November 30, 2021

Re: Comments on I-495 & I-270 Managed Lane Study Supplemental Draft Environmental Impact Statement and Updated Draft Section 4(f) Evaluation

Figure 1: Northbound Inner Loop Throughput 5-6 p.m. – 2017 from DEIS, 2045 from SDEIS

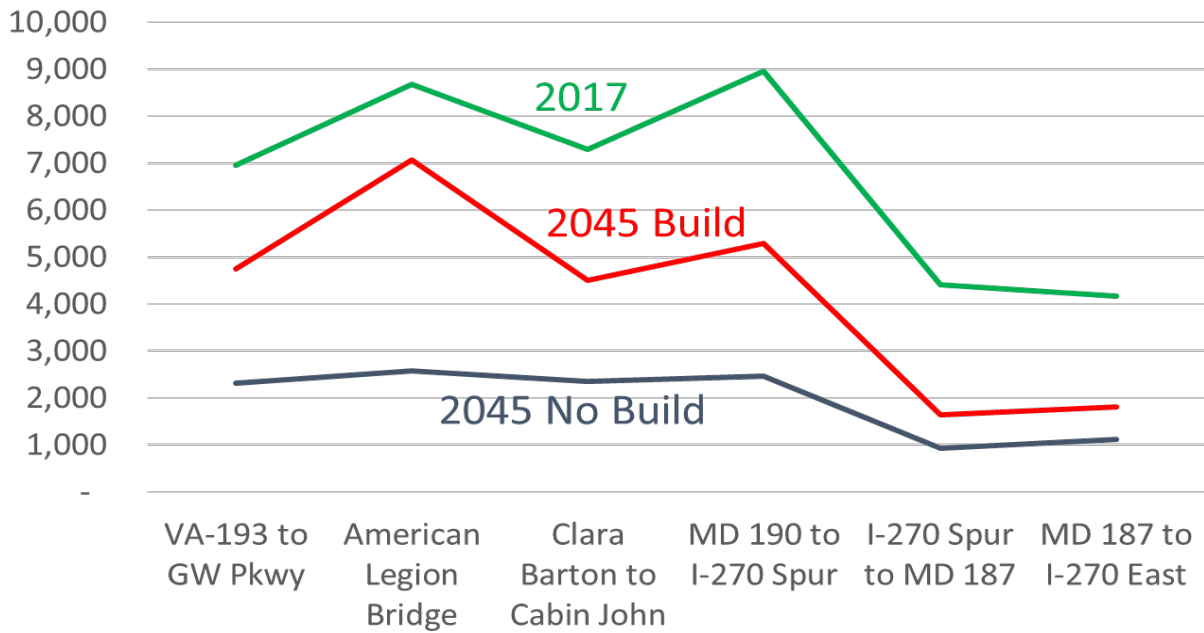
There is no real-world rationale for future throughput being significantly lower than today. Without widening, throughput will be very similar to today because the road is already congested. With widening, throughput also will be very similar to today because traffic flow will be metered by the downstream bottlenecks. The SDEIS compares two sets of wrong 2045 throughput numbers and presents the difference between them as a performance metric. This is invalid.

In the DEIS, the Inner Loop afternoon peak hour volume (5-6 p.m.) on the American Legion Bridge is reported to be 8,760 vehicles per hour. This segment has 5 travel lanes today, so the average volume is 1752 vehicles per lane per hour. In the SDEIS future Build model, 2 managed lanes are added so there would be a total of 7 lanes. The SDEIS reports the throughput as only 3,430 vehicles in the 6-7 p.m. hour, i.e., less than 500 vehicles per lane per hour – less than the traffic volumes on city streets interrupted by traffic signals. This is obviously wrong.

Figure 3: Preferred Alternative 2045 Inner Loop American Legion Bridge Demand, Throughput and Cumulative Unserved Demand (Queue) in the Afternoon Peak Period

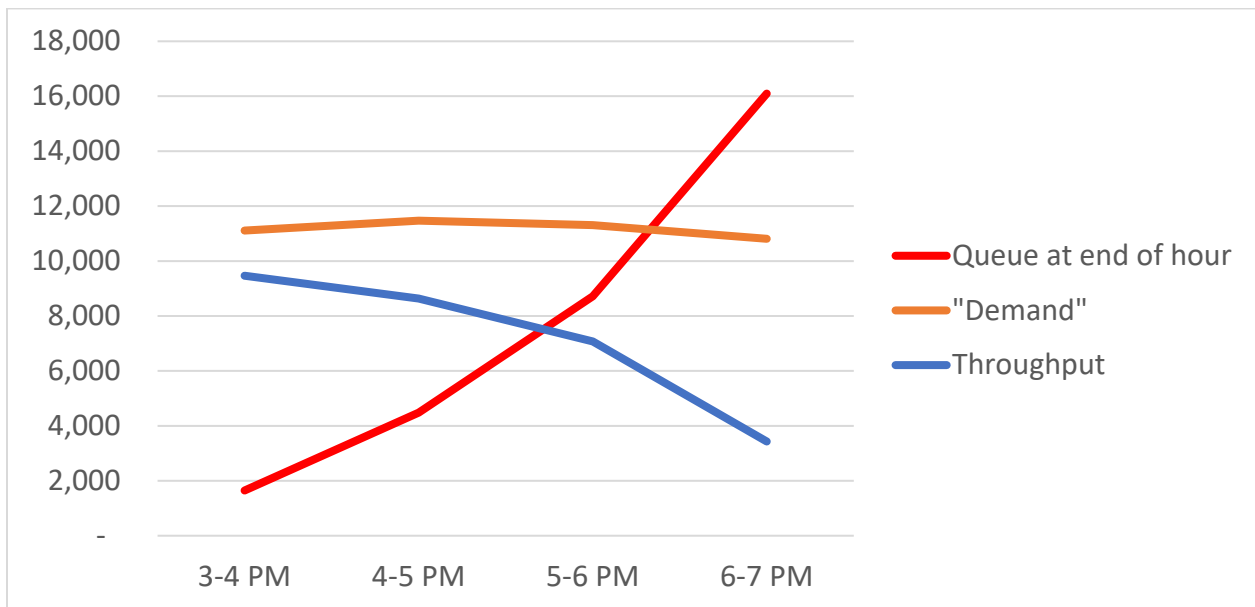
The VISSIM model is overwhelmed by the “garbage in” “demand” and translates it into unrealistically- low throughput. The SDEIS calls the difference between “demand” and “throughput” “demand unserved.” During the afternoon peak period (3 -7 p.m.) in the inner loop there is unserved demand in each of the four hours, and the VISSIM model queue becomes longer and longer through 7 p.m. This queue of cumulative unserved demand is not reported in the SDEIS but is easily calculated from the demand and throughput numbers. Figure 3 shows demand, throughput, and cumulative unserved demand.

Assuming that there is no traffic backed up at the beginning of the simulation (3 p.m.), the traffic backup (queue) grows exponentially over the 4 hours of the afternoon simulation to over 16,000 vehicles at 7 p.m. Clearing this accumulated queue in VISSIM would require many hours of additional simulation

Figure 4: Preferred Alternative 2045 Inner Loop American Legion Bridge Demand, Throughput and Cumulative Unserved Demand (Queue) in the Afternoon Peak Period Illustrative Extension of VISSIM Simulation

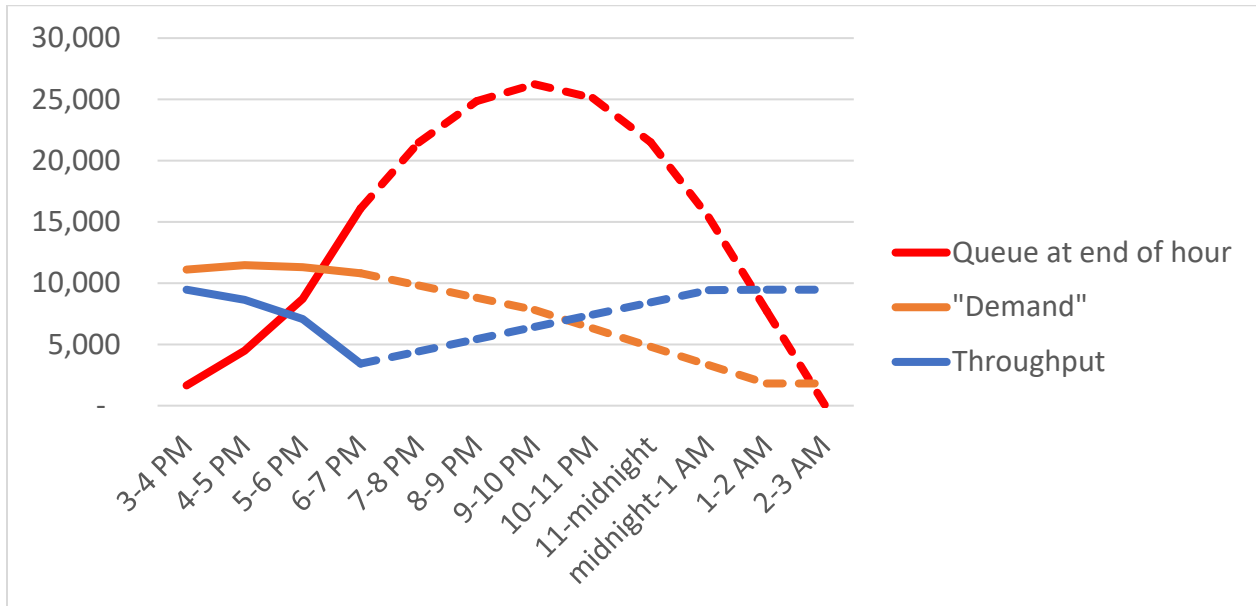
Figure 4 illustrates what the VISSIM model might show if the simulation were extended far enough to eliminate the queue. As long as “demand” exceeds throughput the queue increases. In this illustration, the maximum queue is not reached until 10 p.m. Only after 10 p.m. does throughput exceed “demand” allowing the queue length to shorten and finally be eliminated after 3 a.m.

This illustration is not realistic or the real world but is representative of what the VISSIM model would do if the simulation were extended overnight. Therefore, ending the simulation at 7 p.m. is arbitrary and greatly underreports the congestion problems in the VISSIM model.

Figure 6: Impossible Traffic Forecasts in MWCOG 2040 No Build Afternoon Peak Period (Segments with Volume/Capacity Greater than 1.1 Shown in Red)⁵⁴

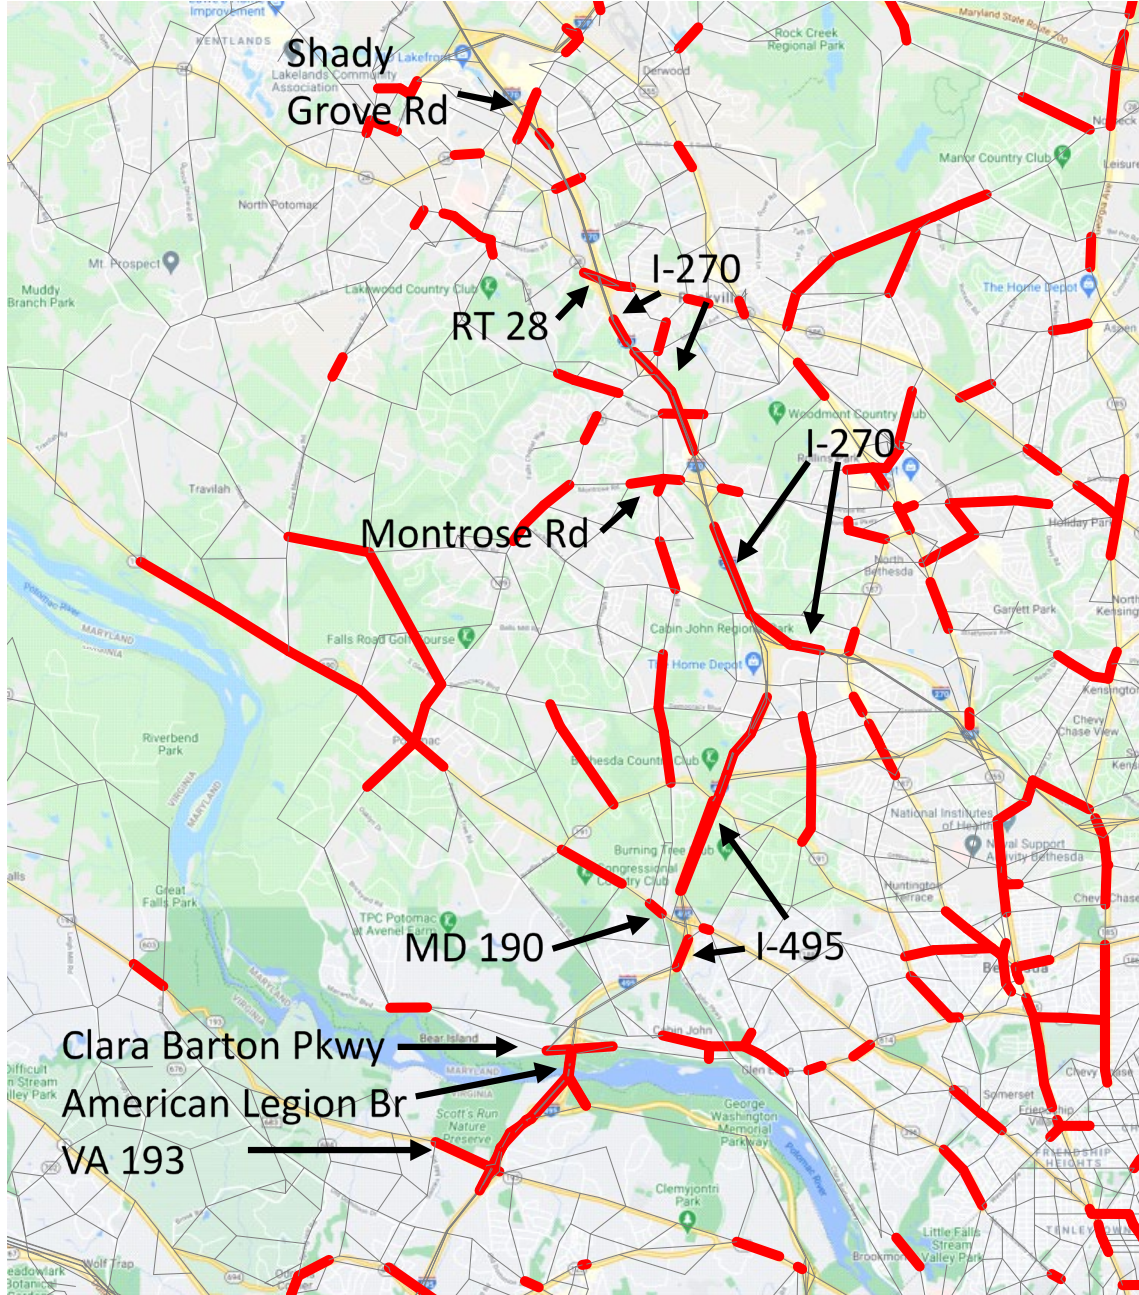
In the DEIS, many segments of I-495, I-270 and other roads are loaded with v/c greater than 1.1 (Figure 6). Horowitz admonishes that the DEIS modeling should not be published with v/c > 1.1. Therefore, these model results should not be used for planning purposes. The DEIS not only does publish these modeling results and uses them for planning, but even goes so far as to represent these over-capacity assignments as a performance measure. This claim is false and is rebutted in the Appendix B of this report section (Section II.F).

Figure 7: Wildly Impossible Potomac Bridge Traffic Forecasts in MWCOG 2040 No Build Morning and Afternoon Peak Periods

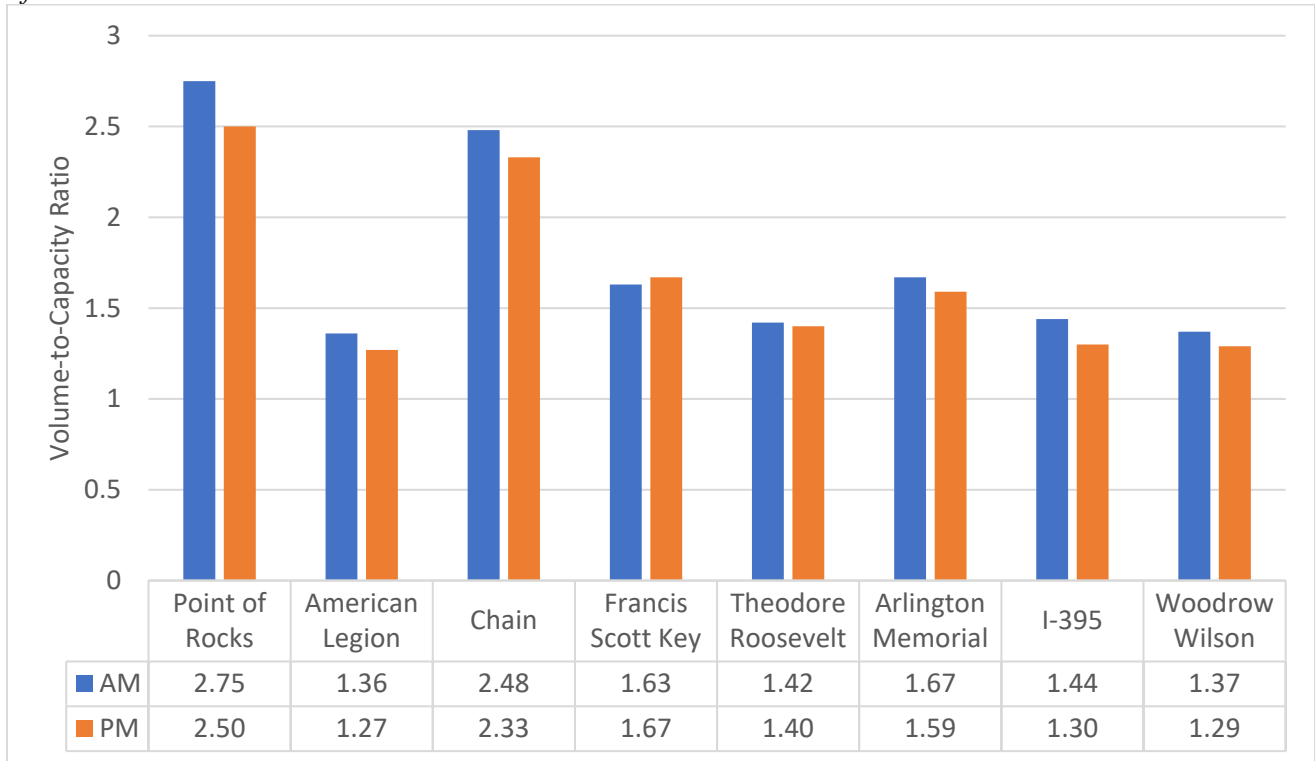
In the DEIS 2040 no build model, MWCOG morning and afternoon peak period traffic volumes for all Potomac River bridge crossings are ridiculously high (Figure 7). All greatly exceed the 1.1 volume-to-capacity ratio threshold, and range as high as 2.75, i.e., the bridge traffic volume is 275% of the highest possible volume.

Figure 11: MWCOG Model Vehicle Minutes of Delay Per Mile for 40 mph Arterial⁶⁴

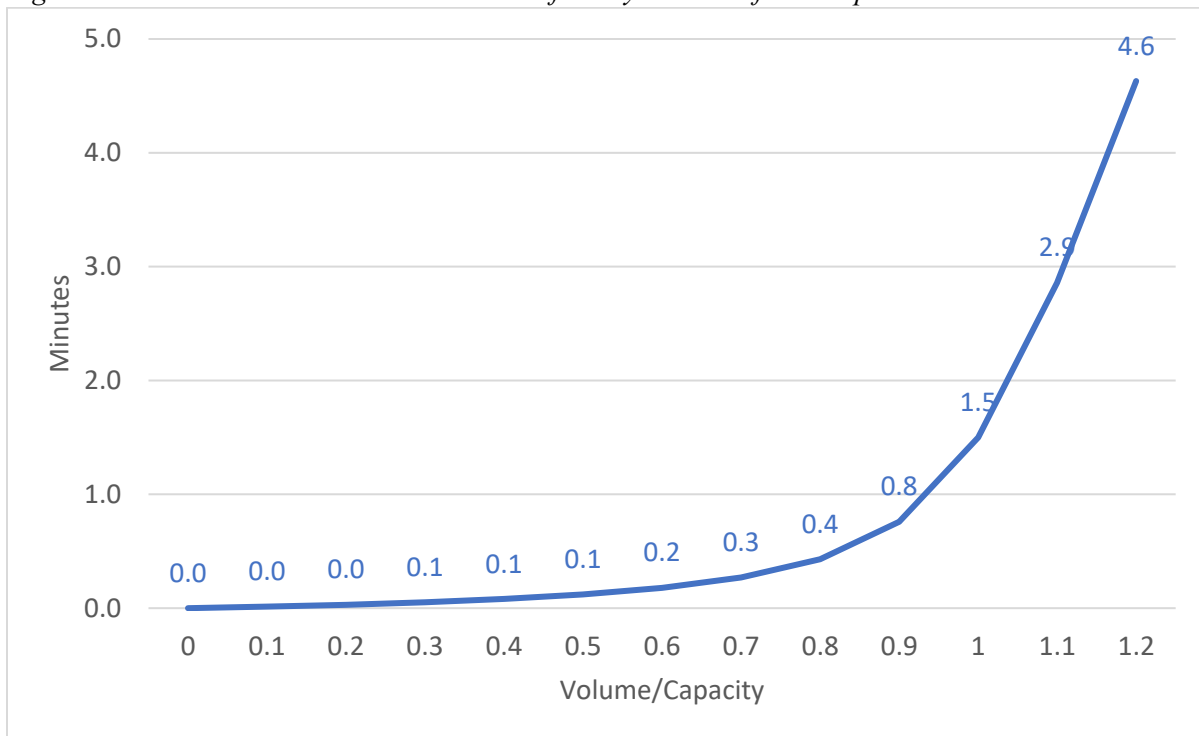
In the figure, a road segment with calculated V/C = 1.0 has 1.5 minutes of delay per mile, and modeled delay grows exponentially with an impossible V/C > 1.0. V/C in the MWCOG model is not capped at 1.2, and there are higher V/C road segments in the model, including the value of 2.75 for the Point of Rocks Bridge shown in Figure 3. Beyond the V/C point shown in the Figure

Figure 12: 2040 No Build Regional Afternoon Peak Period VHD – Road Segments with Possible $v/c \leq 1.0$ vs. Impossible $v/c > 1.0$

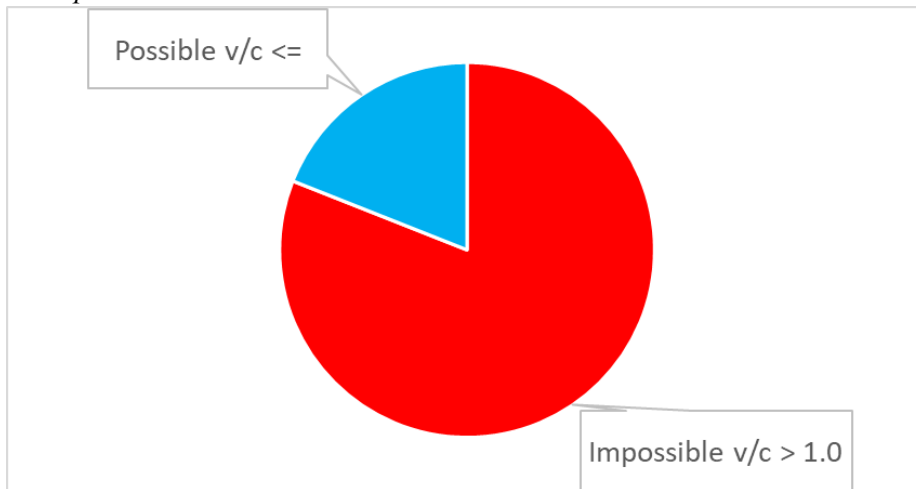
As shown in Figure 12, most (81%) of regional afternoon peak period VHD in the 2040 no build modeling is from impossible assignments with volume-to-capacity ratio exceeding 1.0. The exponential increases in modeled delay as a function of V/C makes MWCOG model VHD more of a metric of model errors than a metric of real-world performance.

Figure 13: DEIS Vehicle Minutes of Delay Per Capita for Montgomery and Prince George’s Counties⁶⁵

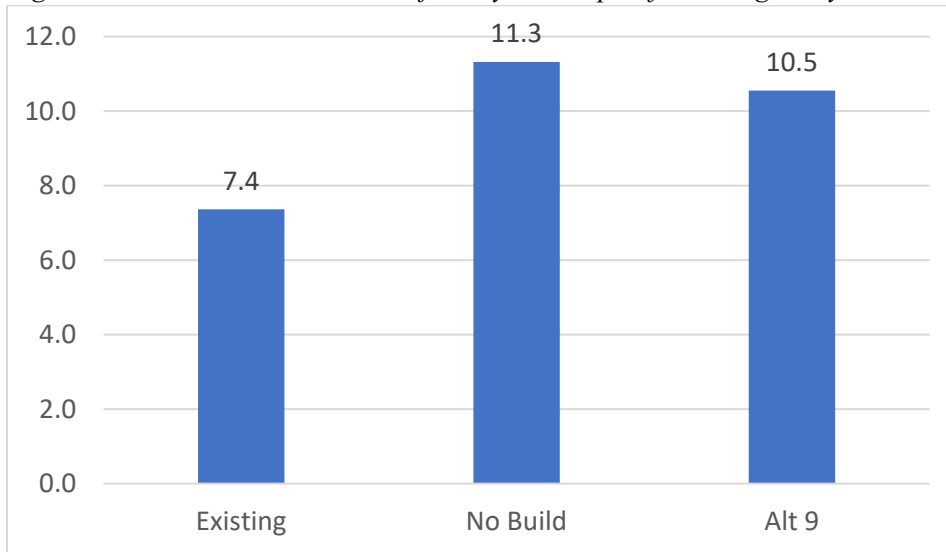
The DEIS VHD calculations are invalid. However, even if they were valid, they do not provide a compelling case for the proposed managed lanes Project. Figure 13 takes the DEIS VHD numbers for a combination of Montgomery and Prince George’s Counties and divides by current and 2040 population so the alternatives can be compared on a per capita basis.

Figure A1: Maryland DEIS Daily Traffic Data and Forecasts (Tables 3-1 and 3-2)

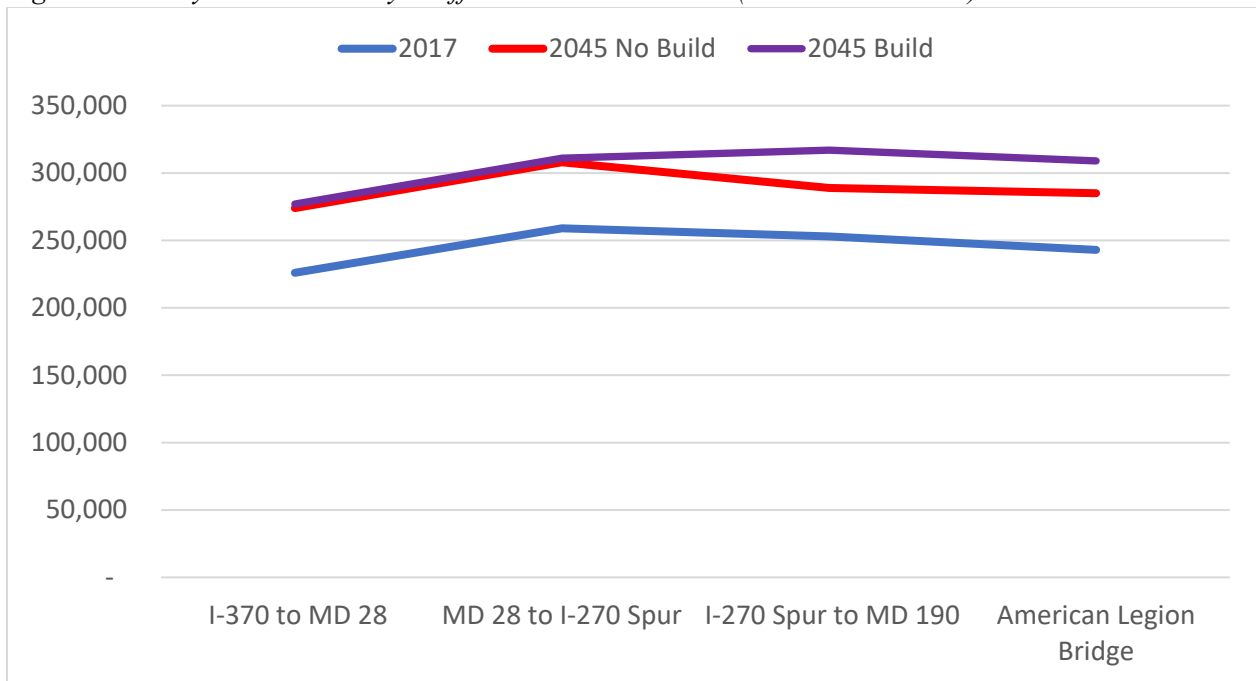
Figure A1 shows SDEIS daily traffic data and forecasts for I-495 and I-270. The SDEIS forecasts significant traffic growth in the 2045 no build alternative and only slightly higher growth for the build alternative.
